City of San Antonio

Re: **Settlers Ridge** **MDP # 044-06**

The Development Review Committee has reviewed **Settlers Ridge** Master Development Plan **MDP # 044-06**. Please find enclosed a signed copy for your files. However, please note the following conditions:

MASTER DEVELOPMENT PLAN

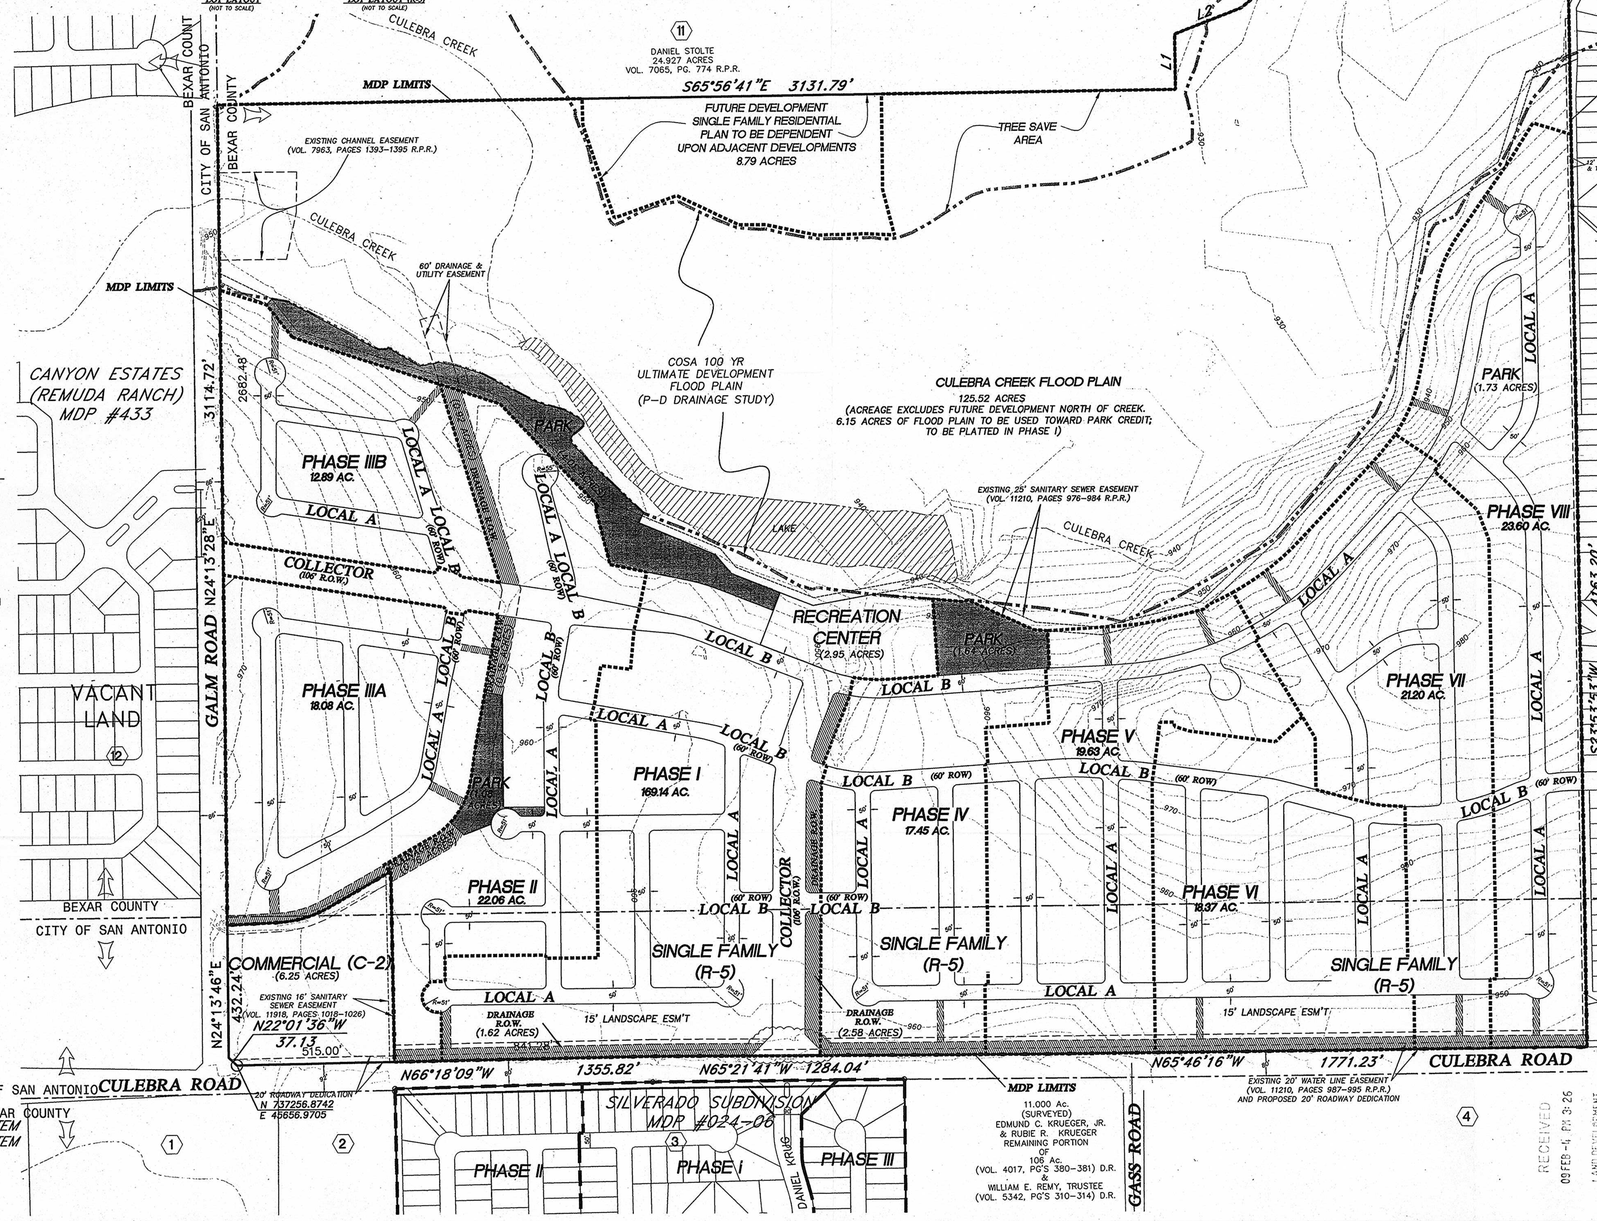
- FM 471 (Culebra Road) The developer shall dedicate 20 feet of right-of-way (Ordinance 98282, October 2, 2003 Major Thoroughfare Plan (MTP)) from the centerline of Culebra Road (Primary Arterial Type A Uniform Development Code (UDC) 35-506(g)(2) adjacent to this proposed project. The total length of property frontage is approximately 4,350 feet.

- Construction of an internal collector street system approximately 1,200 feet in length. Collector street design parameters consist of 70 feet of right-of-way and 44 feet of pavement (Table 506-3). The proposed collector street shall have no houses fronting (UDC 35-515(c)(4)).

- Construction of an internal Local B street system from adjacent development to the collector section, approximately 2,400 feet in length. Local B street design parameters consist of 60 feet of right-of-way and 40 feet of pavement (Table 506-3).

- All roadways shall conform to UDC 35-506(c)(1) Table 506-1: Functional Classification System Description.
- The developer shall be responsible for upgrading the intersection of FM 471(Culebra Road) and Street A and Street B. This includes sufficient left turn storage lanes on eastbound FM 471 (Culebra Road), with a bay taper and transition (UDC 35-506(m)(2) and right turn deceleration lanes (westbound FM 471 (Culebra Road)) with a storage lane and bay taper as it relates to the submitted TIA traffic counts, (UDC 35-502(a)(7), subsection C. Design and construction shall be coordinated with Texas Department of Transportation (TXDOT).

- The developer shall be responsible for upgrading the intersection of Galm Road and Street A. This includes a sufficient left turn storage lane on southbound Galm Road, with a bay taper and transition (UDC 35-506(m)(2) and a right turn deceleration lane northbound Galm Road with a storage lane and bay taper as it relates to the submitted TIA traffic counts, (UDC 35-

502(a)(7), subsection C. Design and construction shall be coordinated with Public Works Traffic Engineering and Development Services TIA Division.

- Provide clear sight distance at each roadway to provide adequate distance for obstruction free viewing distances for approaching traffic. All signage, landscaping and improvements should be selected and located so as to not block these clear sight distance areas.

- Secondary access must be constructed with or prior to the approval of any plat or combination of plats exceeding 125 dwelling units as per UDC 35-506(e)(7).

- When the areas marked as "future development" have been planned, a new parkland dedication plan shall be submitted to this department for review and approval.

- A Master Tree Permit (AP 1369831) has been approved for the residential portion of the MDP under the 2006 Tree Preservation ordinance standards per UDC section 35-523. A $75 review fee will be required to be paid at time of platting and a Tree Canopy Fee ($15/lot) will be required to be paid prior to recordation of each plat. The commercial development is required to meet 40% tree preservation at development and pay tree fees at application and a Tree Canopy Fee of $25/acre prior to plat recordation.

- Streetscape standards per UDC section 35-512 – The new right-of-way on collector and arterial streets will require streetscaping (we recommend preservation of existing trees where available and possible).

- Coordinate with TXDOT for the addition of auxiliary lanes for access onto Culebra Road (FM 471).

- Right turn deceleration and left turn storage lanes will be required for access to Galm Road through separate permit by Bexar County, UDC section 35-502(a)(7)(d).

- Traffic controls shall be warranted as per the Texas Manual on Uniform Traffic Control Devices, approved by Bexar County, and TXDOT.

- Secondary access must be constructed with or prior to the approval of any plat or combination of plats exceeding 125 dwelling units as per UDC section 35-506(e)(7).

- Previously recorded sites 41BX708, 41BX711 (the stone house and stone outbuilding), and 41BX712 are located within the project area: however, the developer allowed an archaeological investigation at site 41BX708 at site 41BX712 no further work was recommended.

- The developer is encouraged to try and preserve in place the standing stone house at site 41BX711 if at all possible. If not possible, and to mitigate the effects of the project to these extremely significant buildings, the HPO requests that Historic American Building Survey (HABS) documentation, Level 1 be done on the stone house and small stone outbuilding and be submitted to the Library of Congress.

- As per conversations between the developer and the HPO, the stone house will be relocated to an area within the development that is mutually agreed upon by the developer and the HPO.
